**Additions and Renovations
Platt Technical High School**
Milford, CT

ADDENDUM NO. 3

November 22, 2019

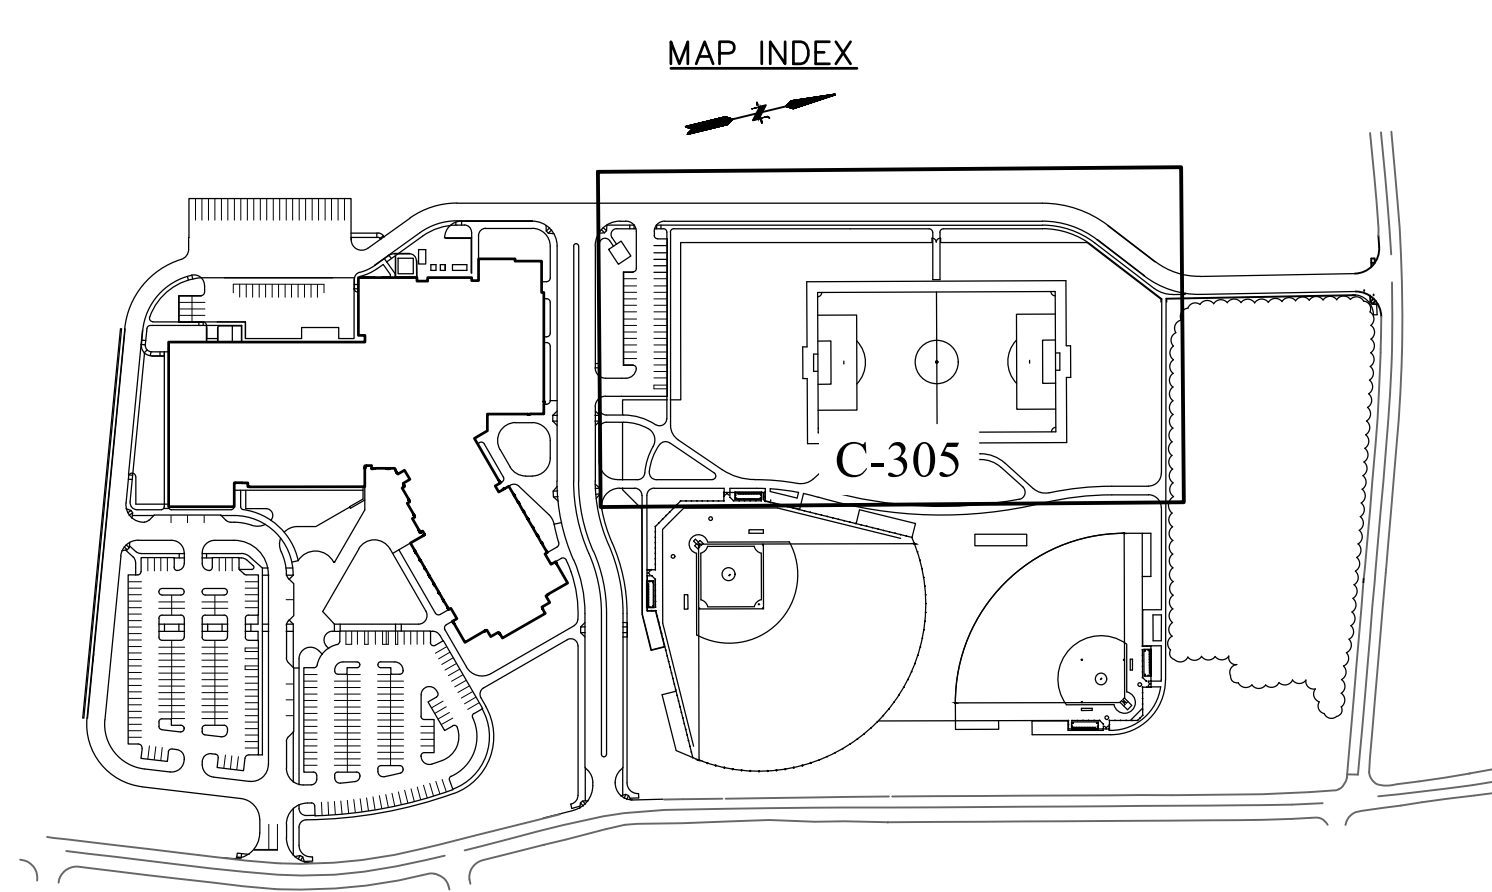
ADD 3-006 C-305 – SITE DRAINAGE PLAN

Drawing revised to show the limit of the drainage sand layer.

RA3-01

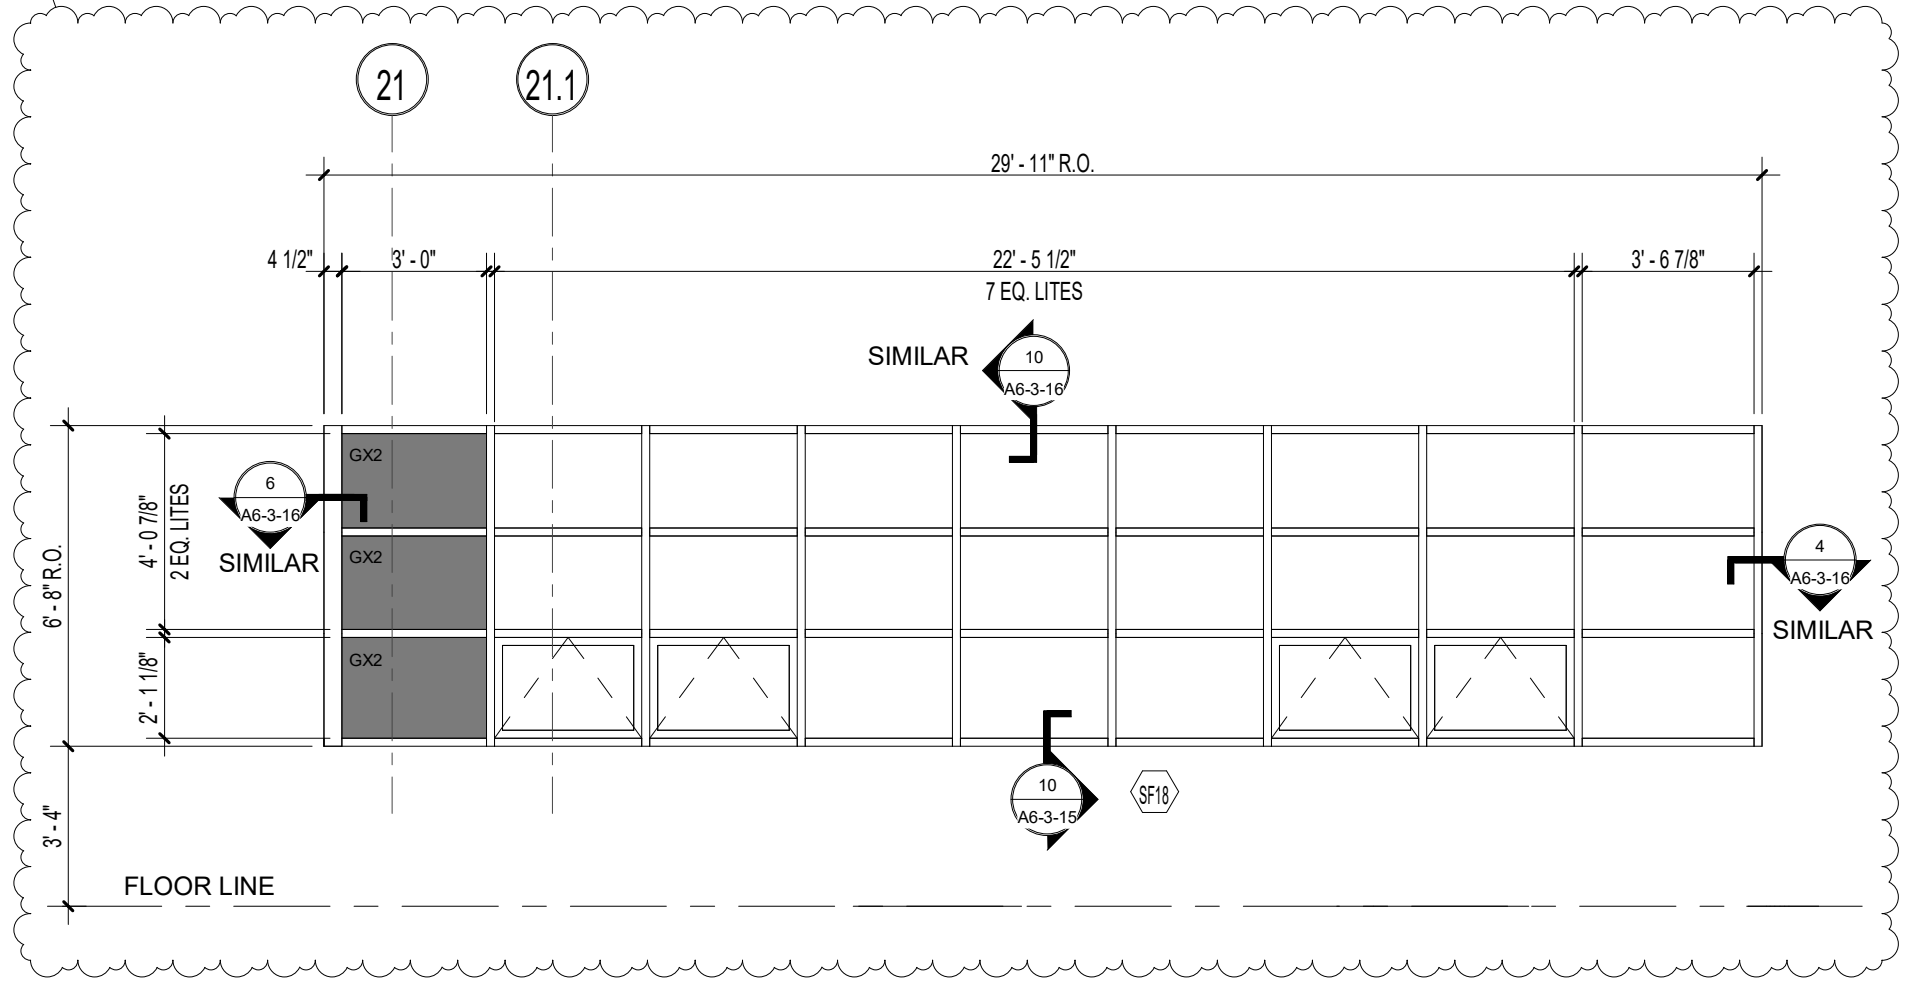
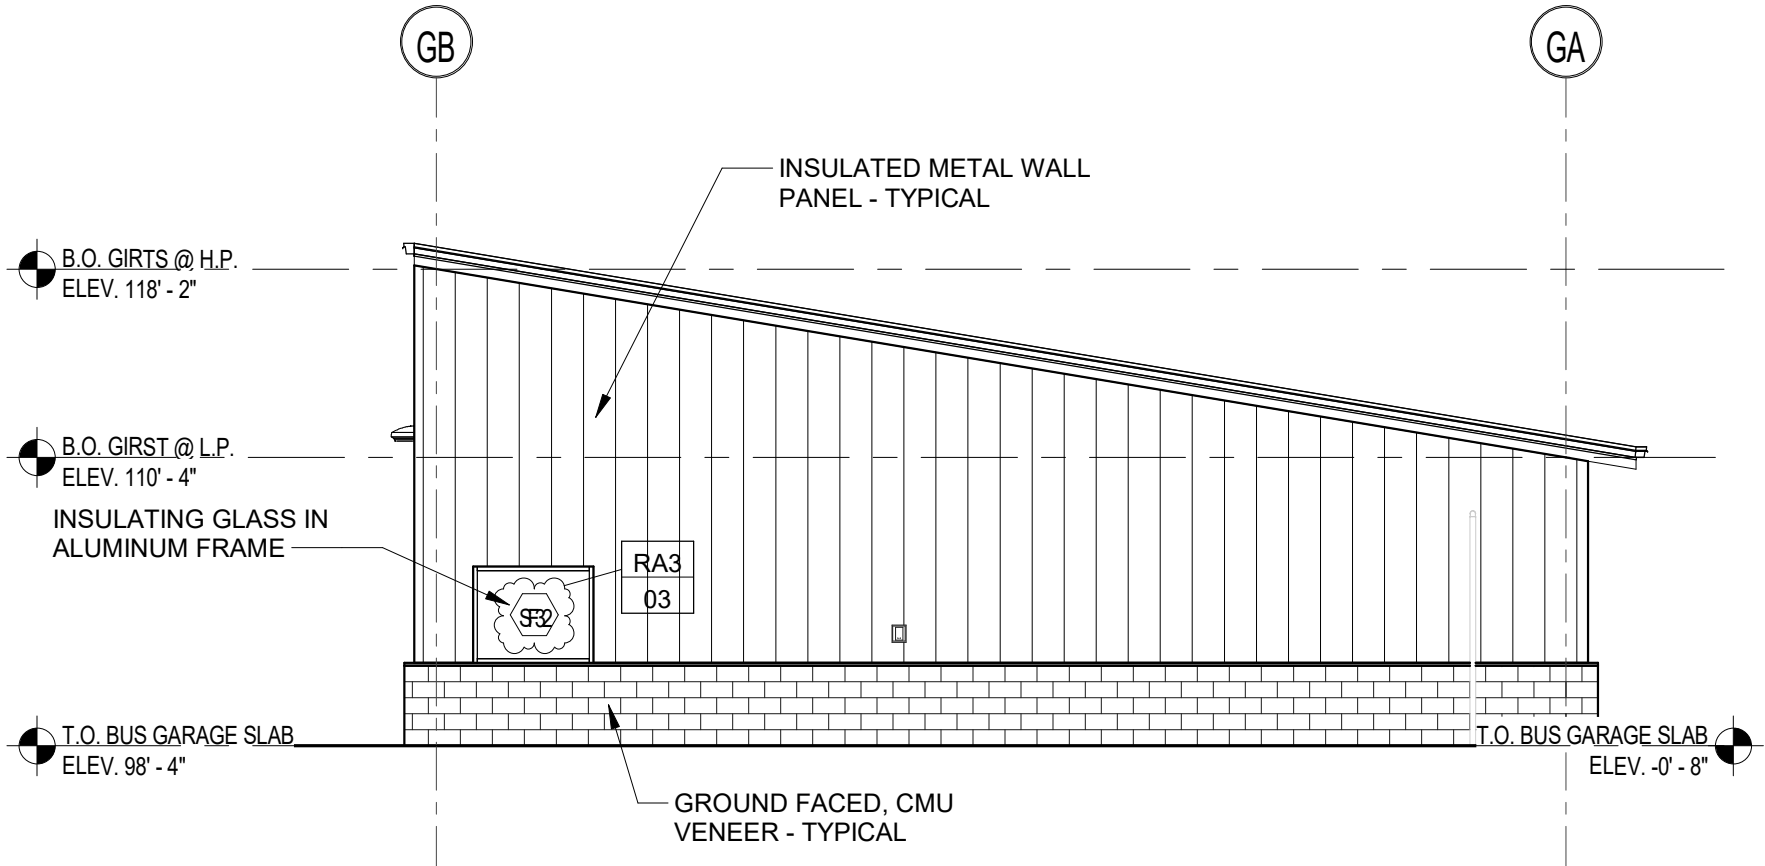
Curtain Wall Type CW22:
The Abbreviation “SG” refers to Glass Type “Security Glazing – Exterior.”
- ADD 3-015 A6-3-5 – STOREFRONT TYPES**
ADD Storefront Type SF18. Refer to Sketch RA3-01.
- ADD 3-016 A6-3-7 – INTERIOR STOREFRONT TYPES**
Interior Storefront Type ISF 14:
The Abbreviation “SG” refers to Glass Type “Security Glazing – Interior.”

RA3-06

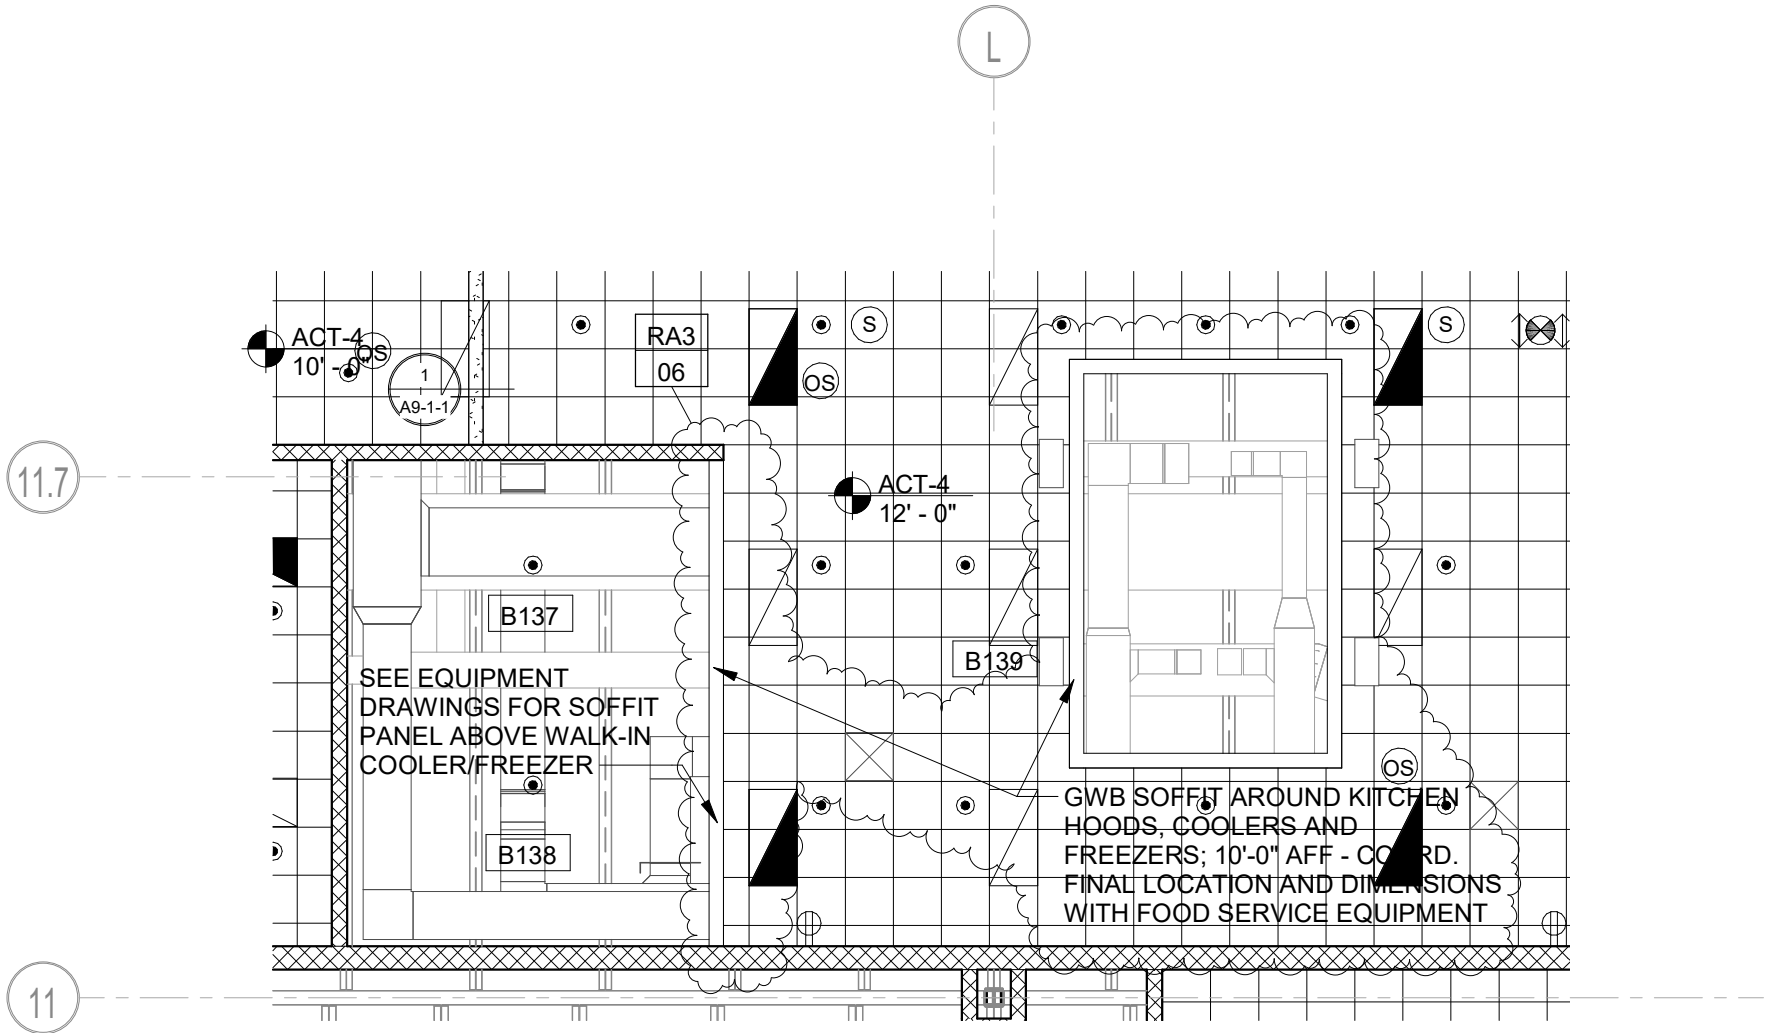
ADD 3-018 **A8-1-1B – FIRST FLOOR REFLECTED CEILING PLAN – Area B**
Added GWB soffits at the perimeter of Kitchen Equipment Hoods, Walk-in Coolers and Freezers at Rooms B105, B124, B124A, B124B, B124C, B137, B138 & B139.
Refer to Sketches RA3-05 and RA3-06.
